ADDENDUM NO. CC-1

30 August 2016

NORTHEAST COMMUNITY COLLEGE WELLER BUILDING BASEMENT REMODEL
801 East Benjamin Avenue
Norfolk, NE 68702-0469
BCDM Project No. 3507-01

6 LOWER LEVEL DEMOLITION PLAN
1/8" = 1'-0"

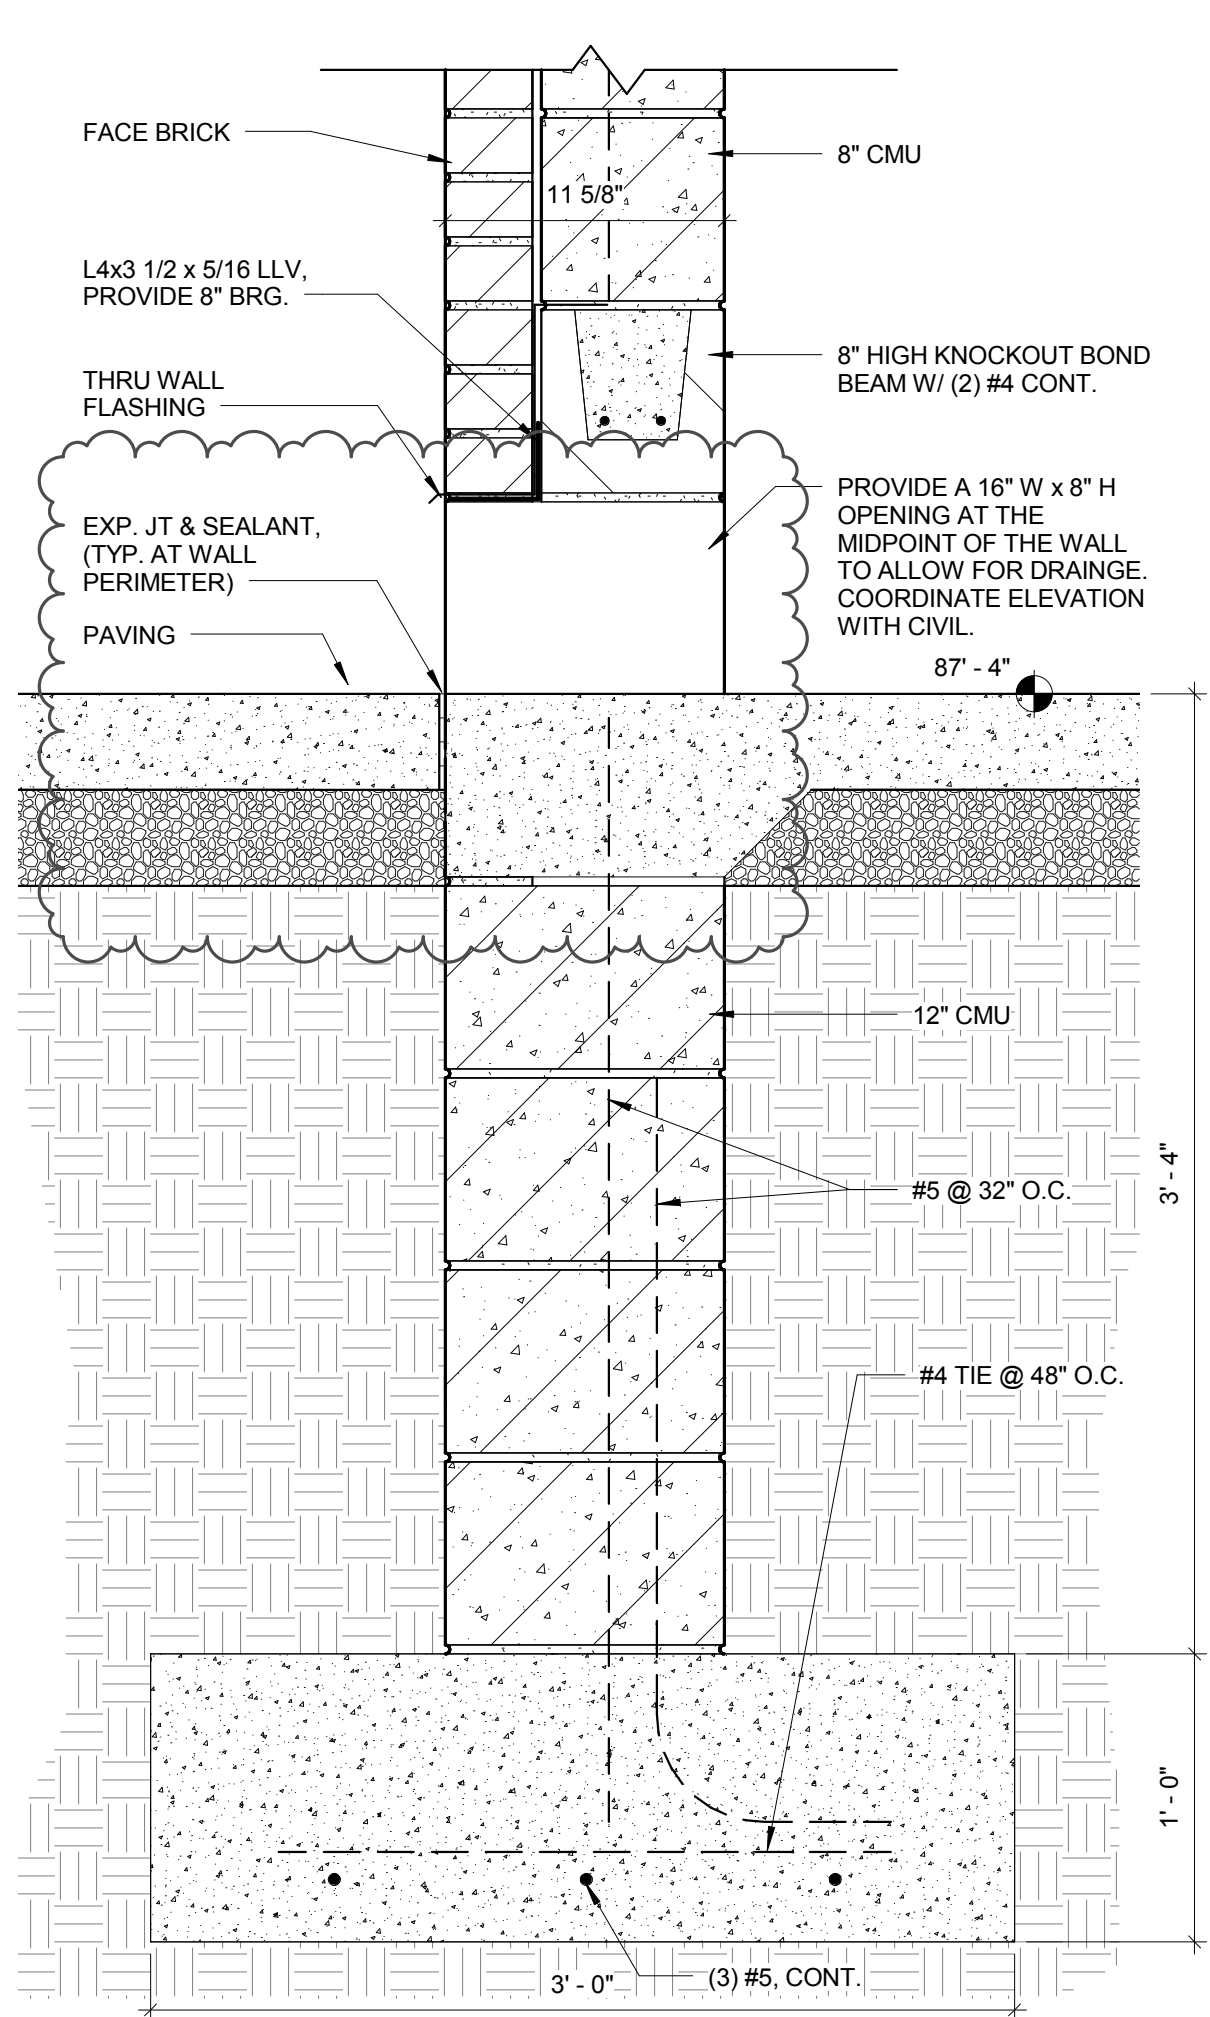
- a. 6/A1-1 Lower Level Demolition Plan revisions generally include:
 - i. Revised door EB133-A (remove & replace door & adjacent masonry)
 - ii. Revised site work
 - iii. Revised width of sub-slab plumbing cuts
- b. 1/A1-1 Lower Level Floor Plan revisions generally include:
 - i. Revised door EB133-A (new door & masonry tooth-in)
 - ii. Revised site work
 - iii. Layout
 - iv. Bollards & curb at dumpster enclosure
 - v. Revised width of sub-slab plumbing cuts
 - vi. Revised north end of Group Fitness room
- c. 7/A1-1 Section Through Screen Wall:
 - i. Revised slab edge.
